## **ABBREVIATED PLAT AGENDA**

**April 15, 2026**

STAFF REVIEW AND RECOMMENDATIONS  
PUBLIC HEARING  
APRIL 15, 2026

ABBREVIATED PLAT: GERONDALE ESTATES  
LEGAL DESCRIPTION: SEC 21, T17N, R01W S.M., AK  
PETITIONERS: RICHARD GERONDALE  
SURVEYOR/ENGINEER: ACUTEK / PINARD ENGINEERING  
ACRES: 10.03 +/- PARCELS: 2  
REVIEWED BY: CHRIS CURLIN CASE #: 2026-026

EXHIBIT E

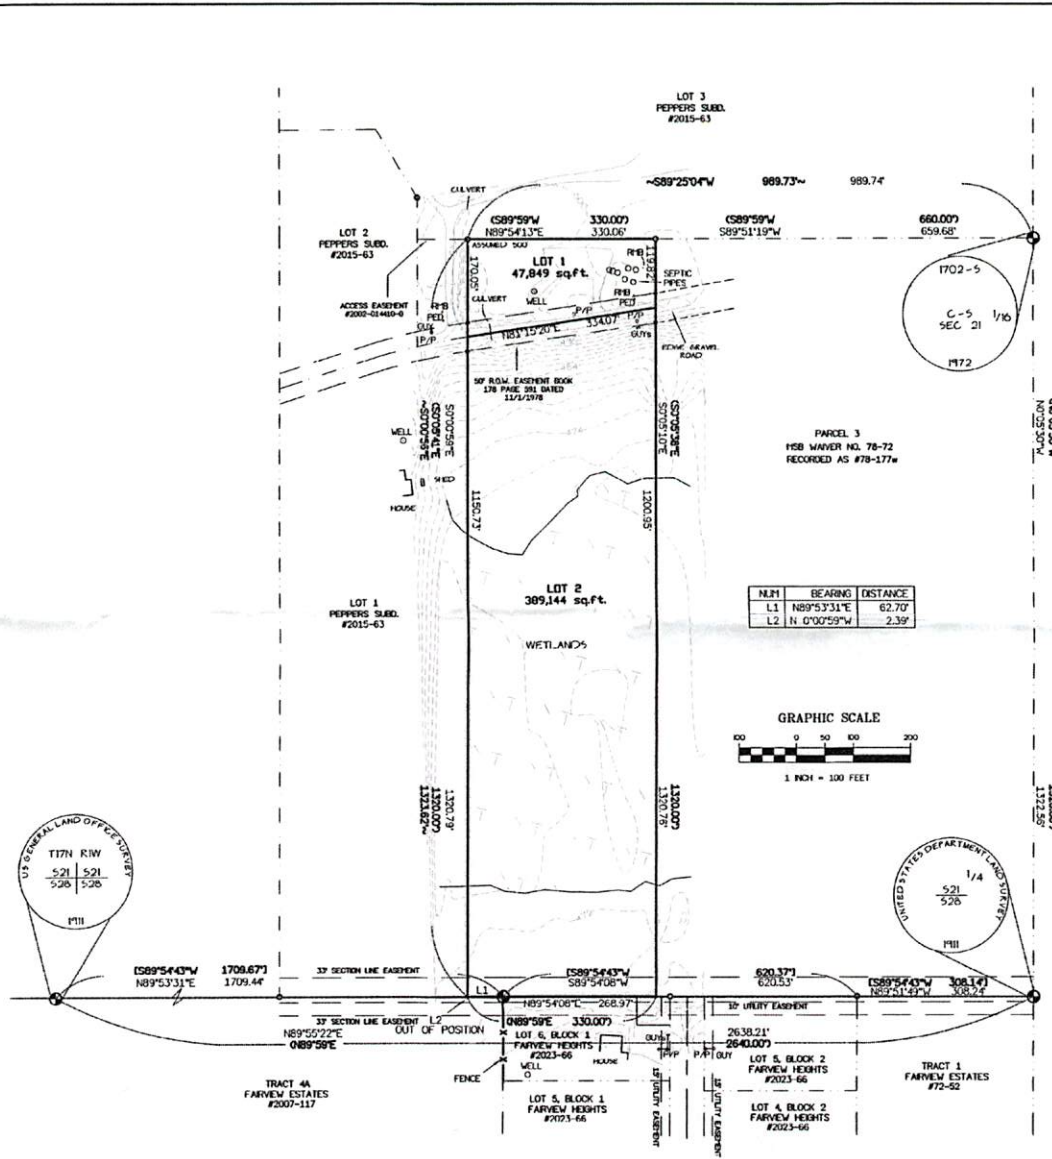
In review GCI has no comments or objections to the plat, attached is the signed plat for your records.

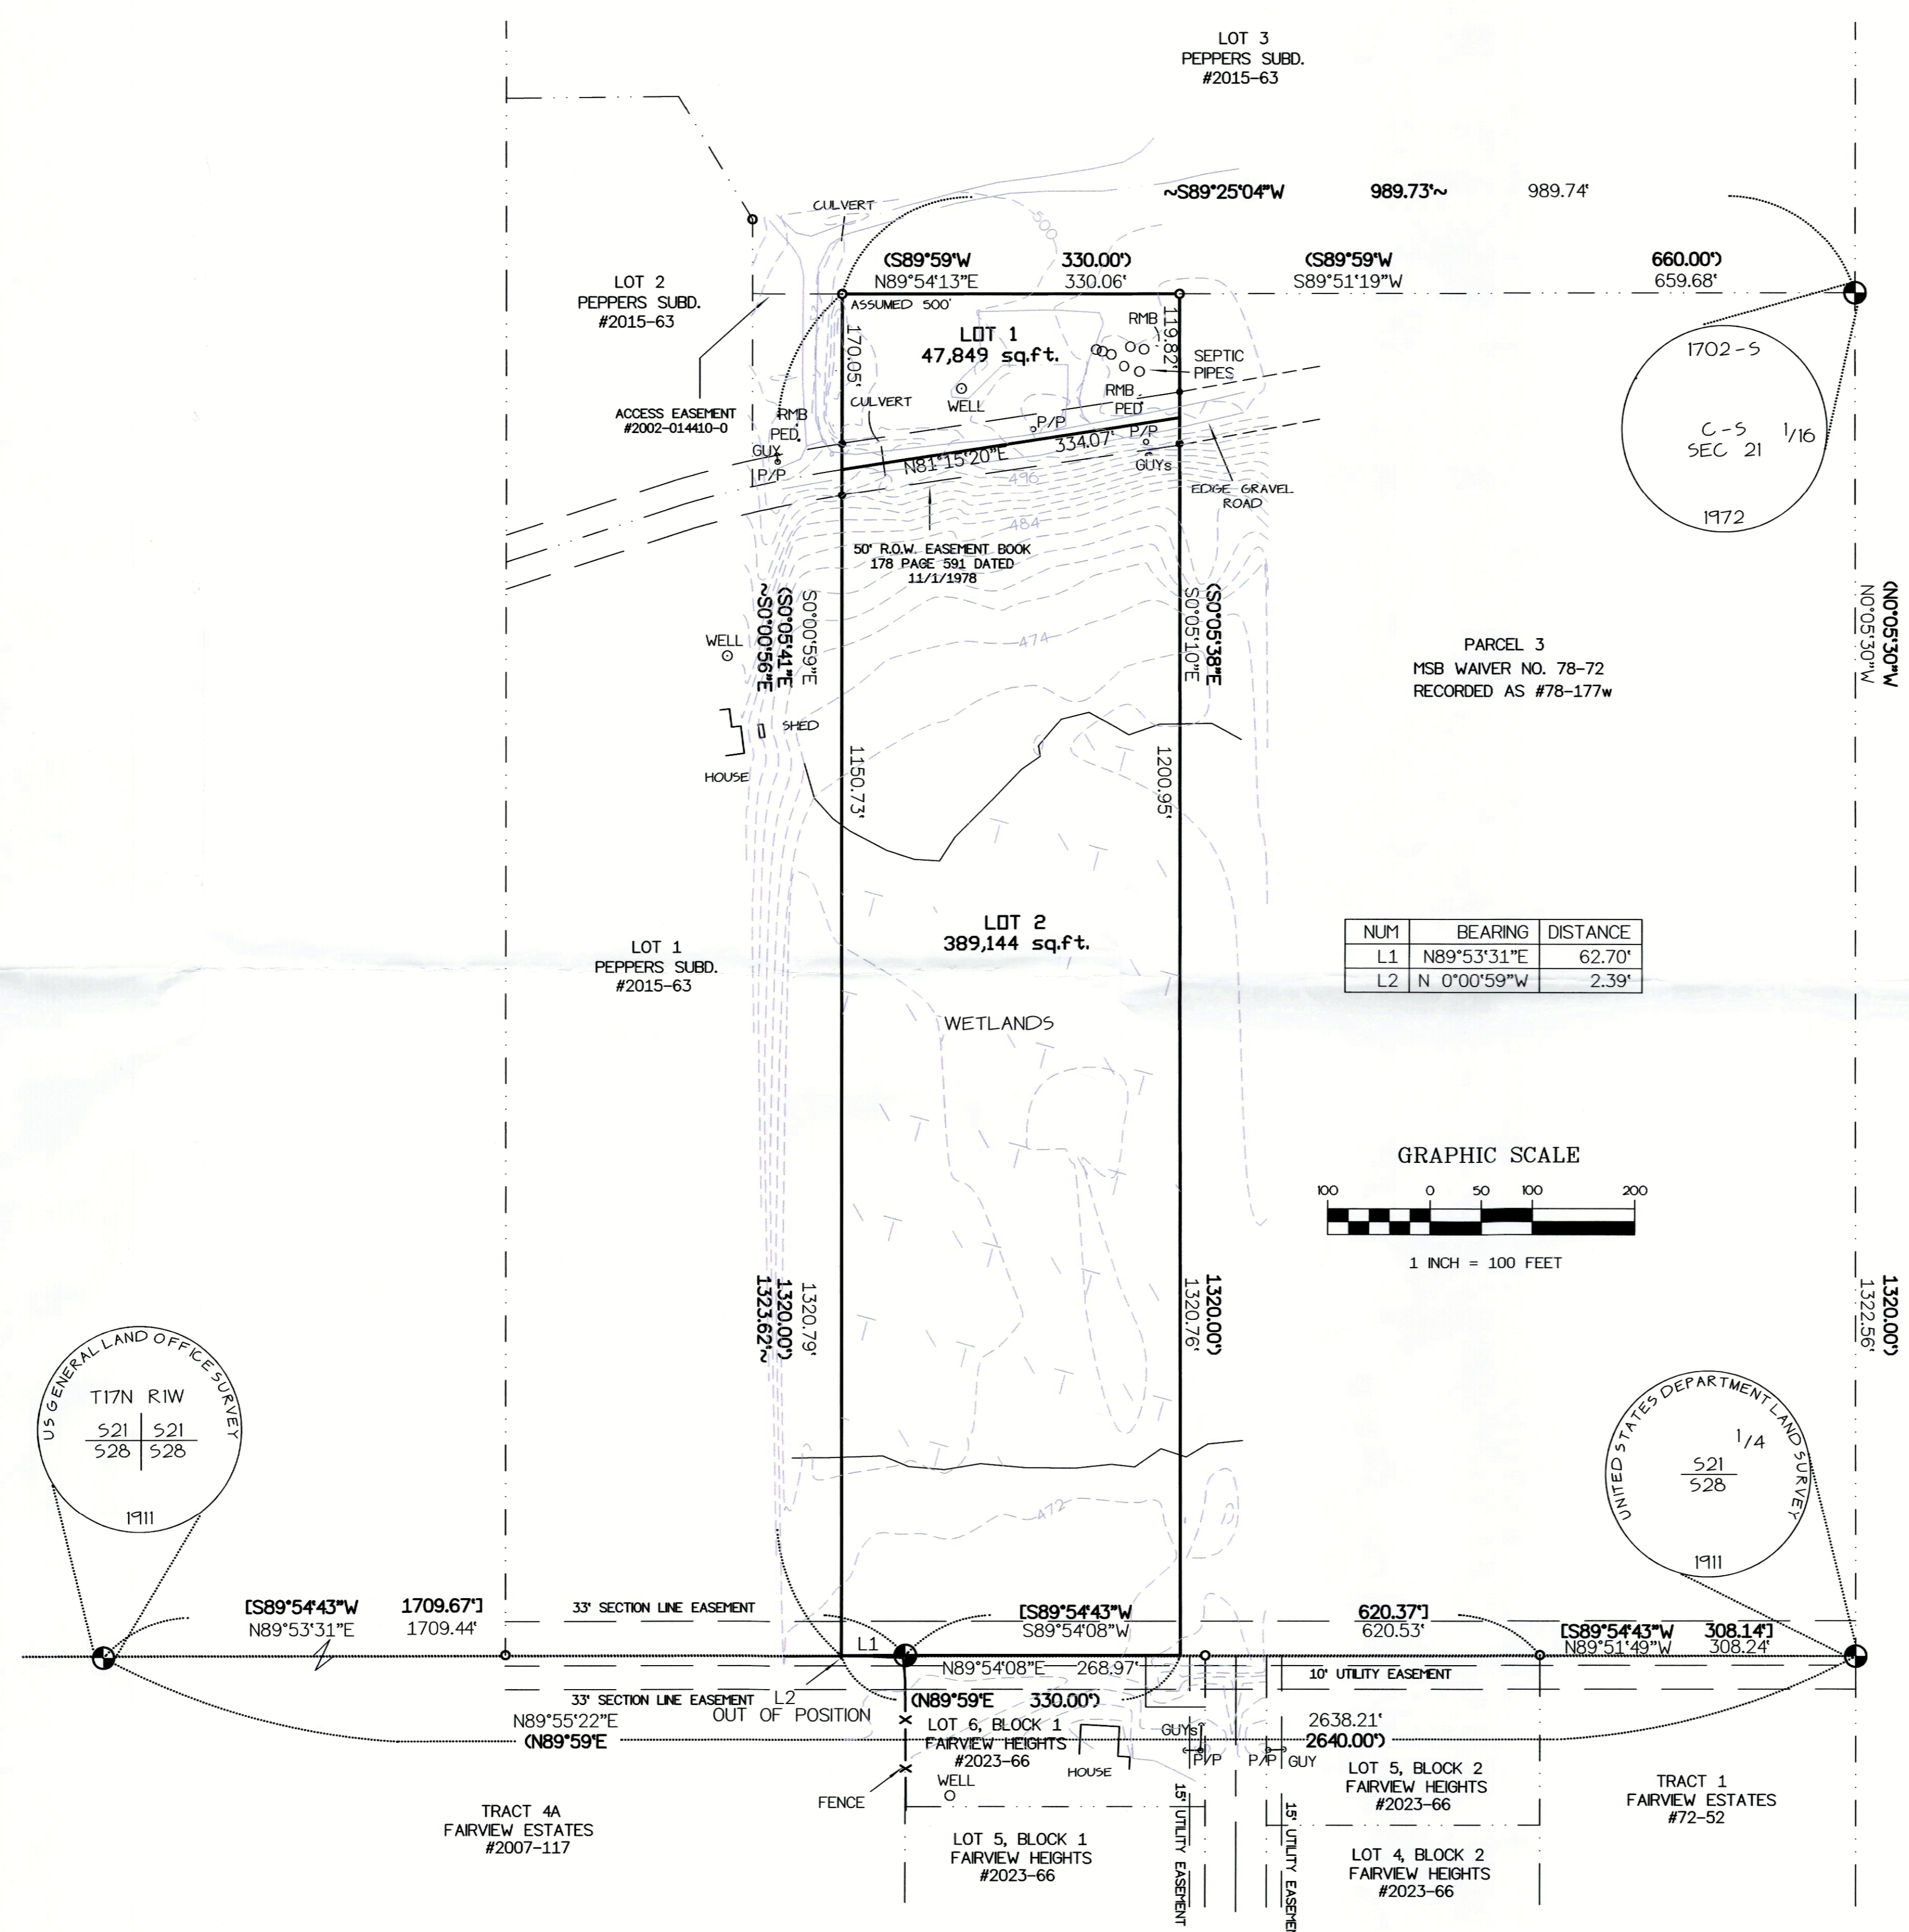
Comments: I am concerned about proposed access to this subdivision. Where is the borough approved road proposed to be? The center 5/8 of this property spans a wetlands/swamp. A road down section line on the south side would seriously affect properties to the east including our property & Jackfish Landing airstrip. Strongly opposed to that.
